Addendum 1

October 30, 2017

Energy Plant Repairs and Modifications
University of South Carolina
State Project Number: H27-Z215

1 ELECTRICAL SITE PLAN @ BLOSSOM STREET
SCALE: 1" = 10'

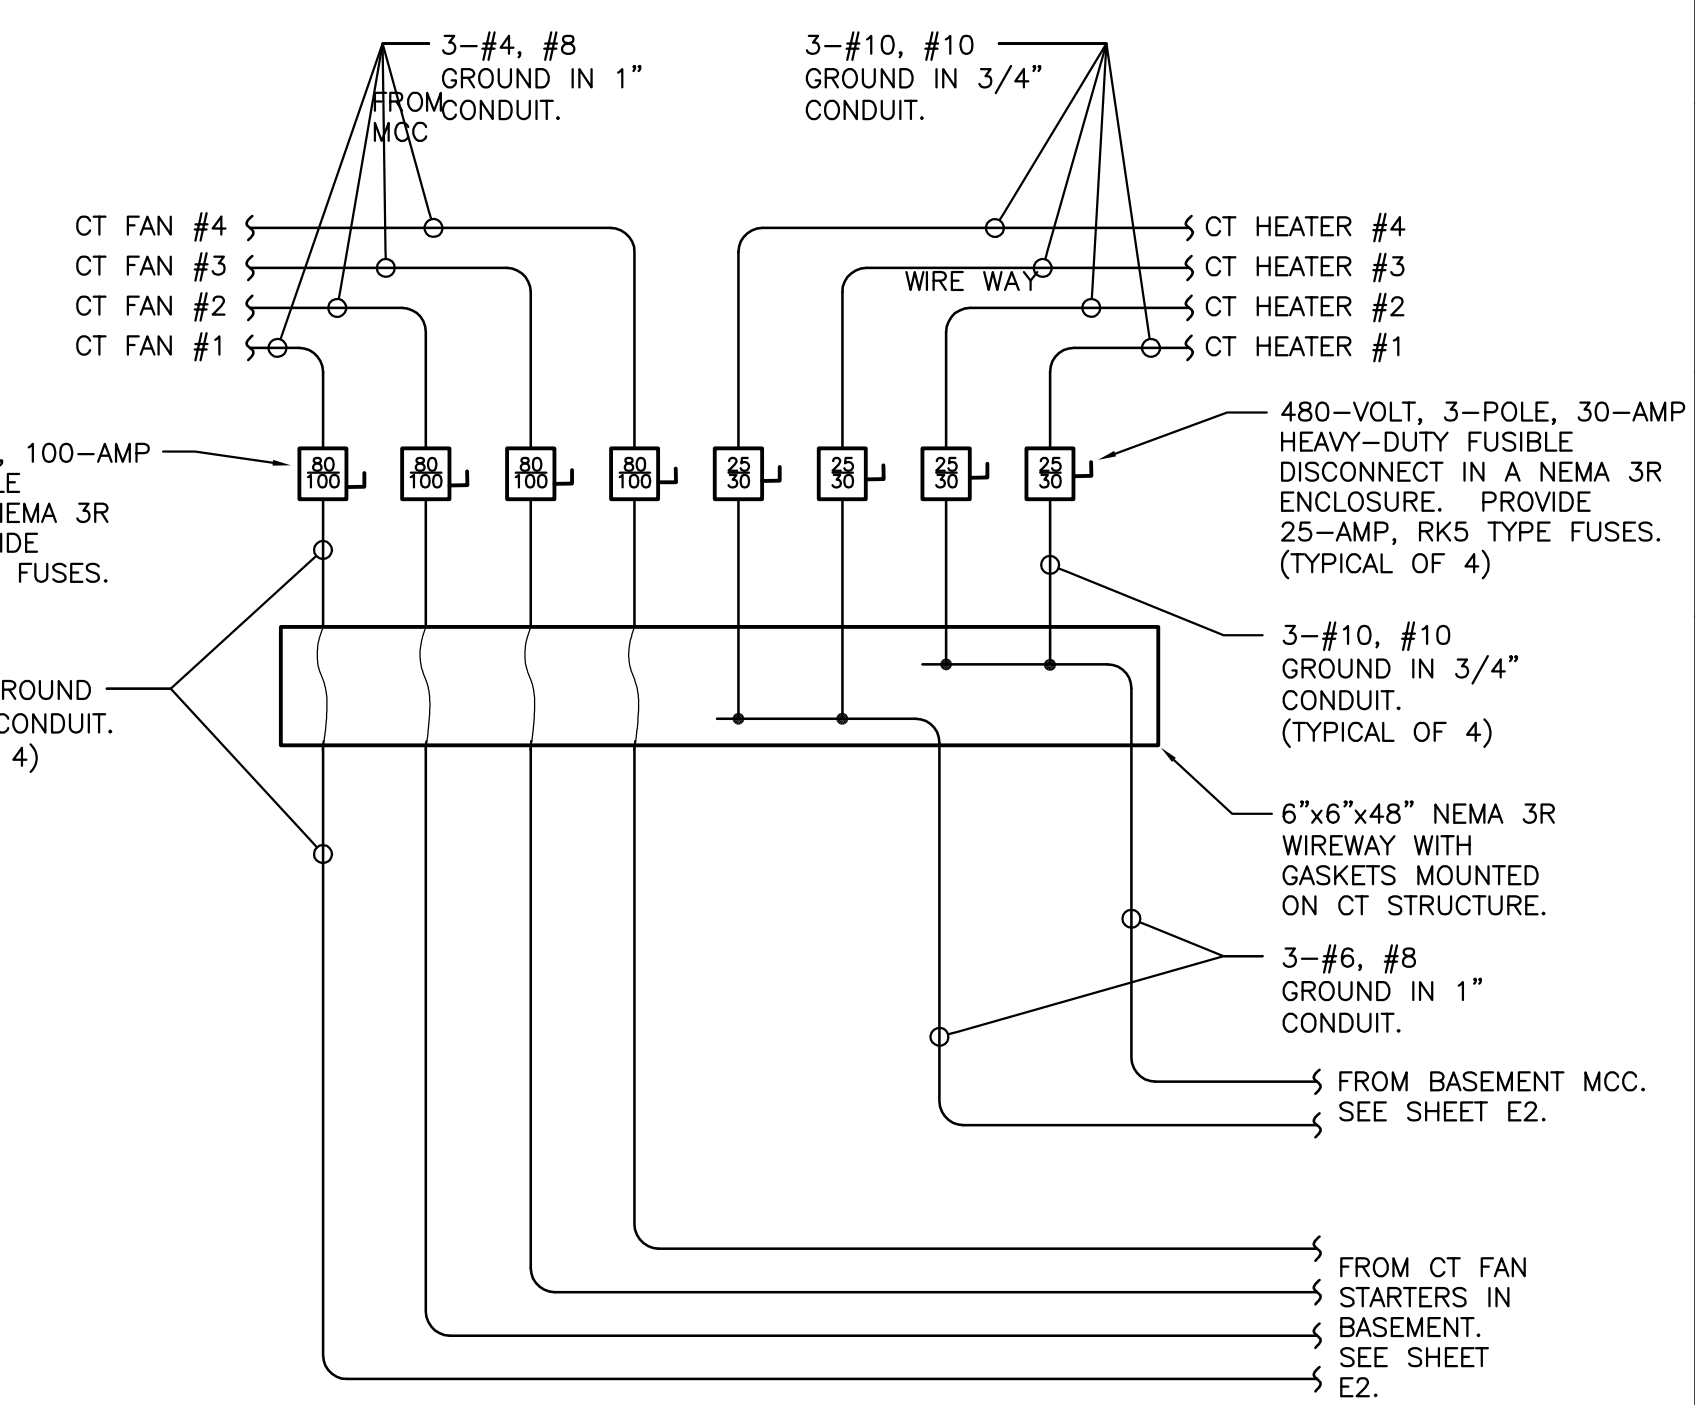
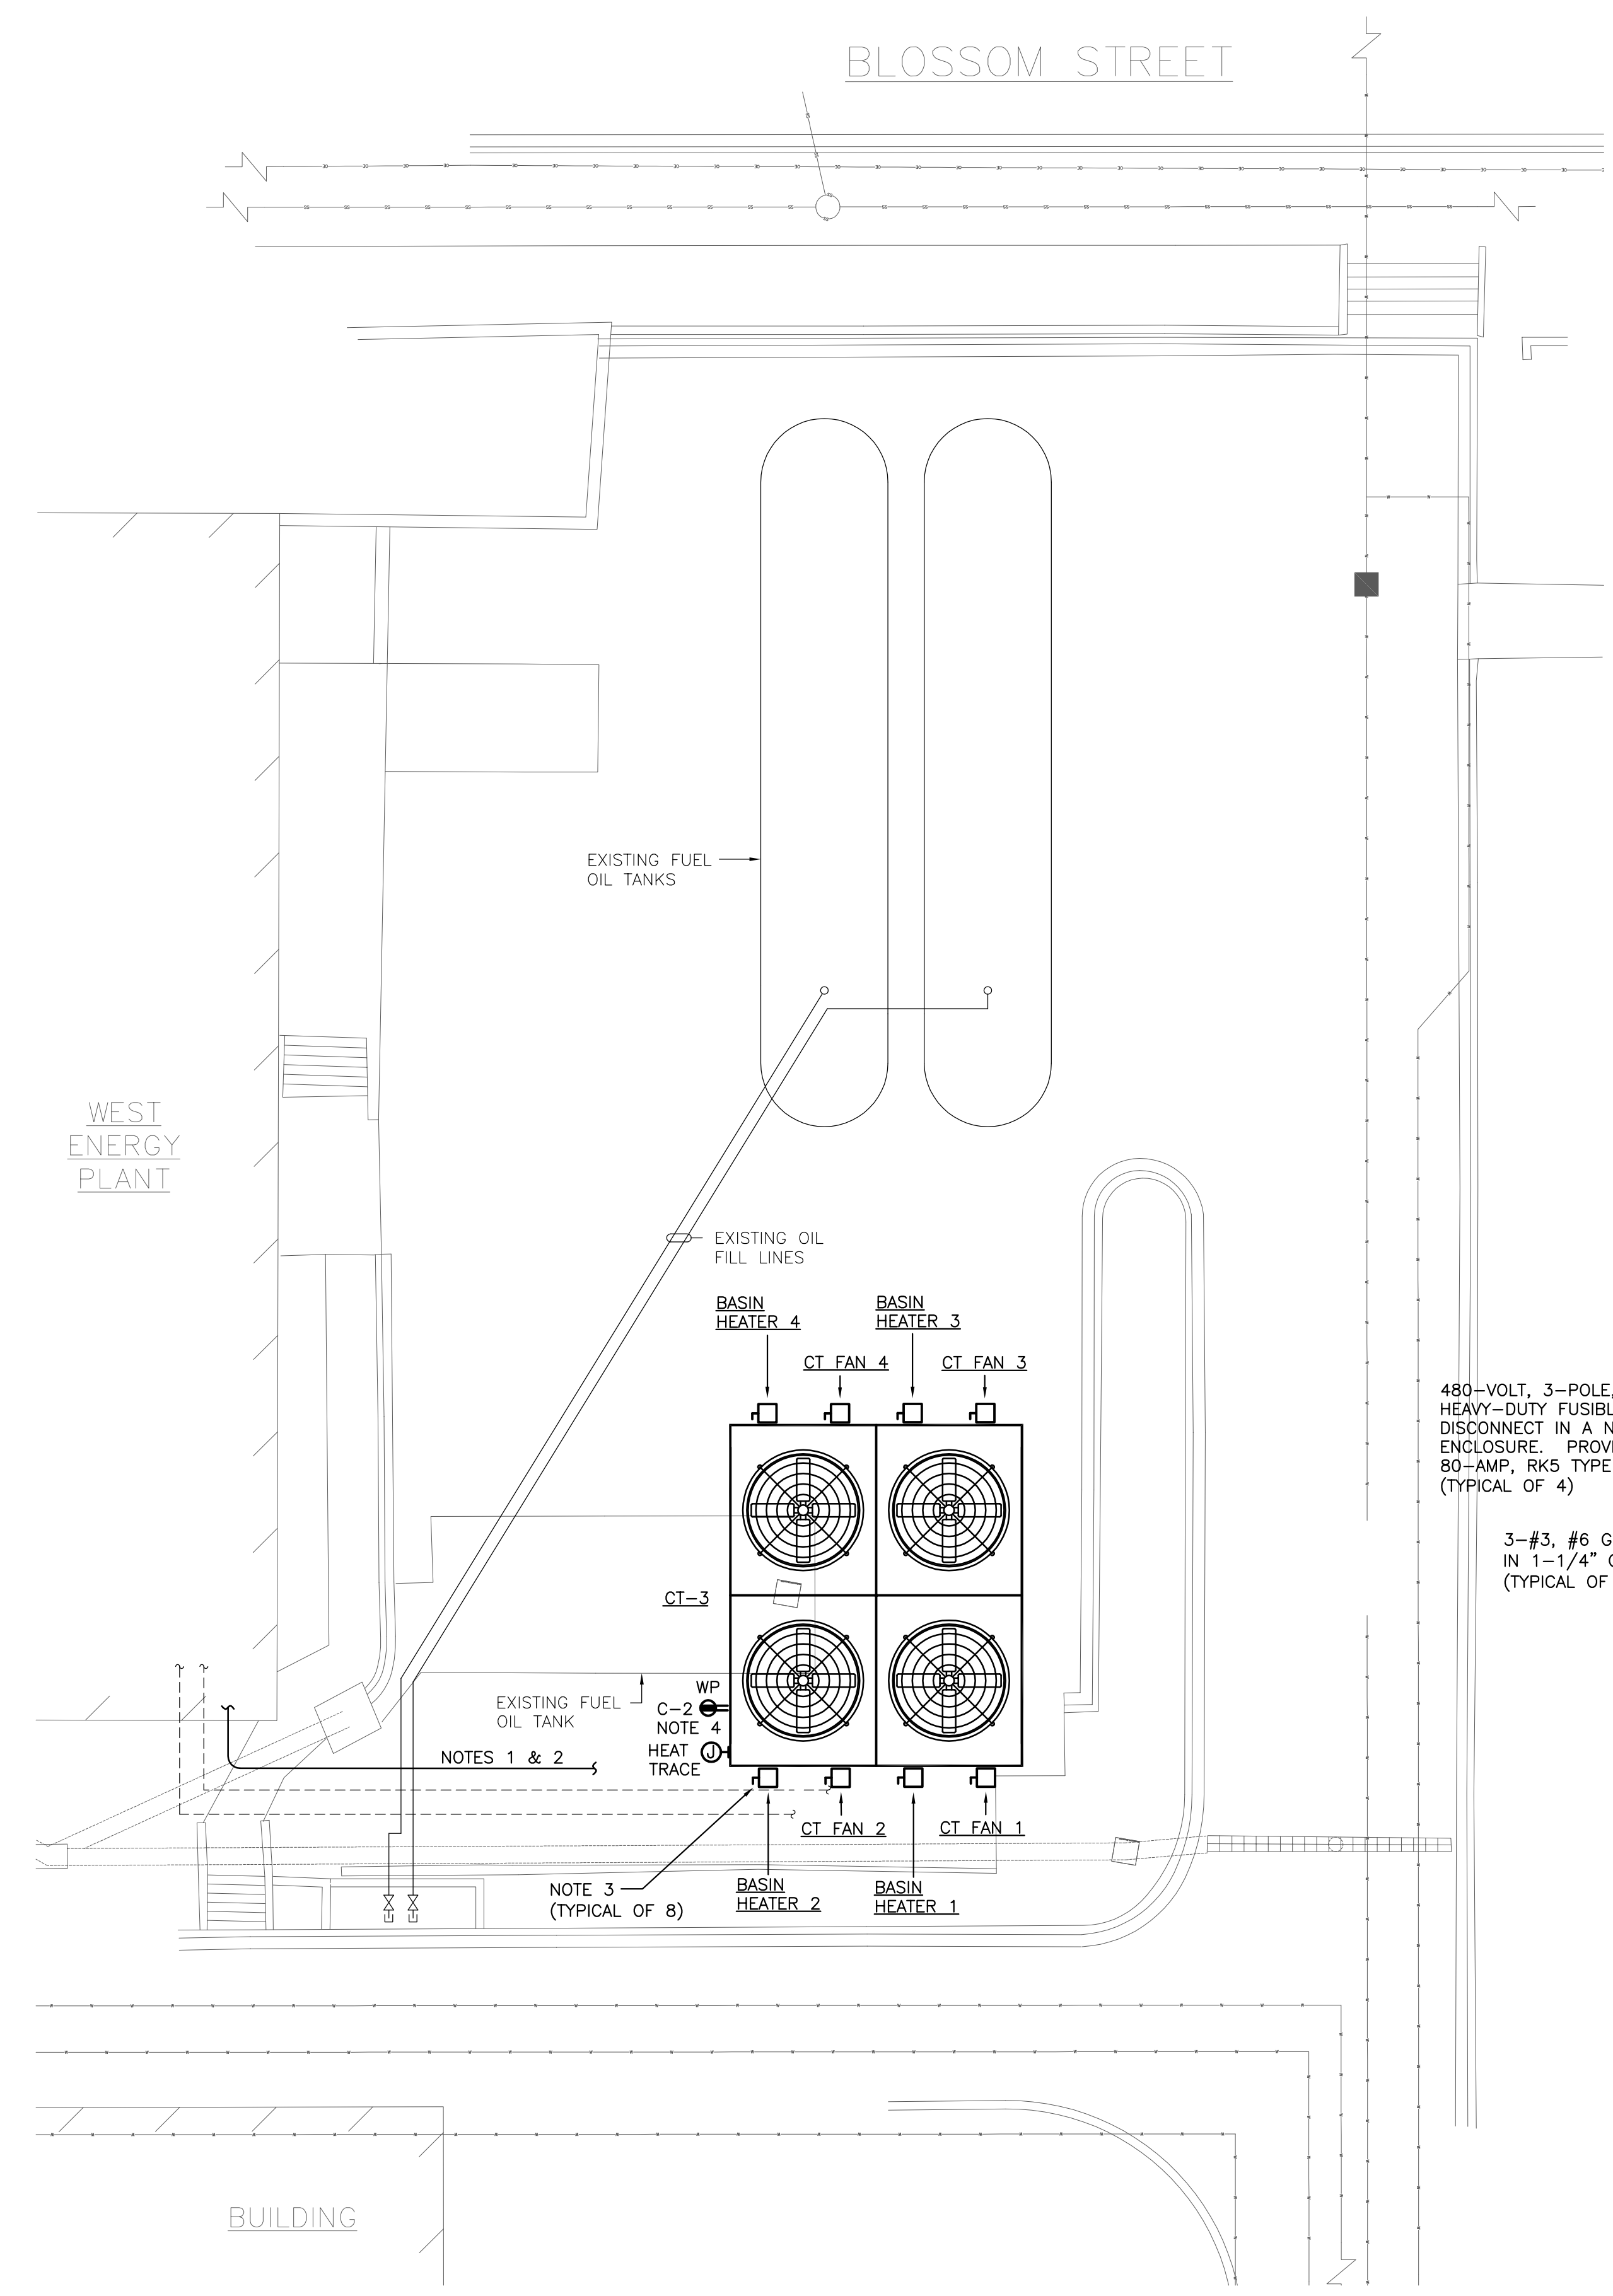
3. Revision: Reference Drawing E1 Electrical Site Plan at Blossom Street. Clarify that underground electrical conduit shall be offset from condenser water piping.

4. Revision: Reference Drawing E1 Electrical Site Plan at Blossom Street. Clarify that electrical contractor shall include connections from basin heater controllers to heating elements.

- PROVIDE ELECTRICAL CONNECTIONS FOR BASIN HEATERS THROUGH CONTROLLER(S) MOUNTED ON COOLING TOWER TO EACH INDIVIDUAL HEATER MOUNTED ON BASIS. COORDINATE EXACT QUANTITIES AND LOCATIONS WITH MECHANICAL CONTRACTOR.
